Peer Review File

Manuscript Title: Photocatalytic solar hydrogen production from water on a 100 m²-scale

Reviewer Comments & Author Rebuttals

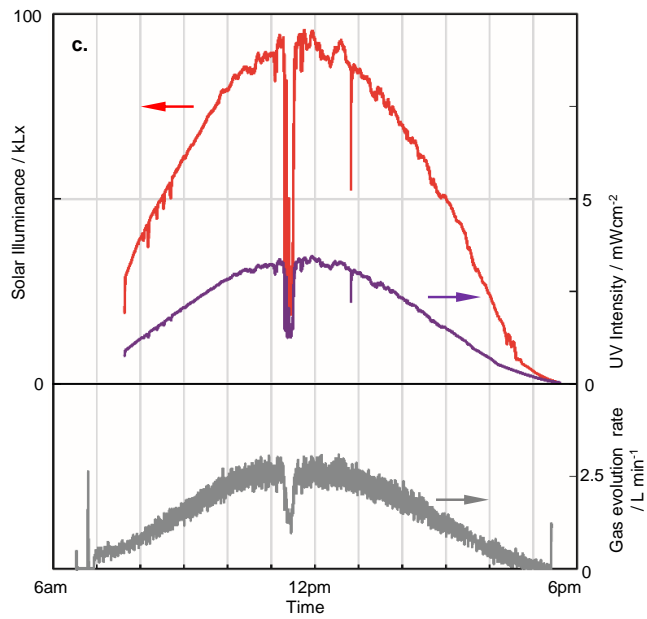
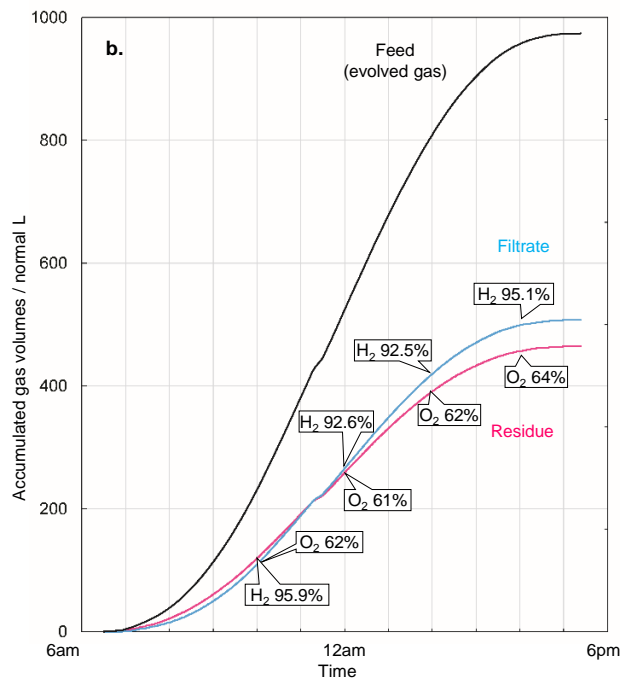
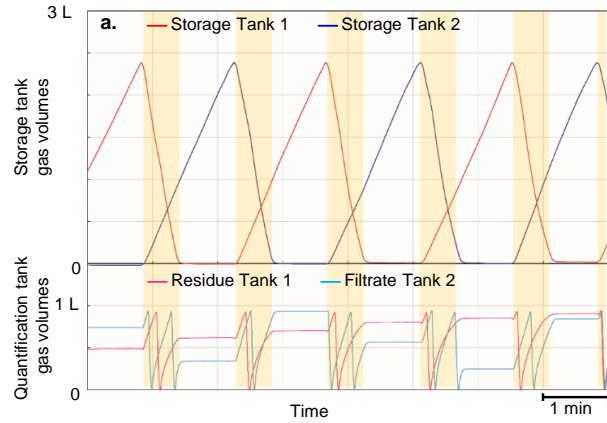
Humidity of the O₂/H₂ combined and separated gas streams is not consistently indicated, the molar fraction of hydrogen and oxygen is indicated as 2.0, without proof or indication of potential variation. Generally, the experimental data is not indicating the experimental error/reproducibility (i.e. error bars). In my opinion, every experimental data point (efficiency, rates, stoichiometric ratios, separation efficiency, etc.) requires an error bar.

“The gas production rate was correlated with the sunlight intensity, ...” (Line 117)

“The variations of solar illumination intensity, ultraviolet intensity, and the gas evolution rate in the water splitting panel reactor are also shown in Fig. 3c. The performance of the photocatalyst panel reactors follows the fluctuation of the weather conditions quickly. The total feed of humid oxyhydrogen gas on the day was 970 L under the average atmospheric pressure and ambient temperature of 106.9 kPa and 24.4°C on average of the daytime. The feed gas contained hydrogen and oxygen at the molar ratio of 2.0 as well as water at its saturation vapor pressure (approximately 3.0 kPa). Therefore, the total amount of hydrogen in the feed gas equalled 27.2 mol. The feed gas was separated into 505 L of hydrogen-enriched filtrate gas saturated with water vapour. The hydrogen-to-oxygen molar ratio in the filtrate gas exceeded 94% on average. Therefore, the hydrogen yield in the filtrate was 19.9 mol. Accordingly, the hydrogen recovery proportion reached 73% ...” (Line 155)

“The hydrogen recovery proportion was calculated according to the equation:
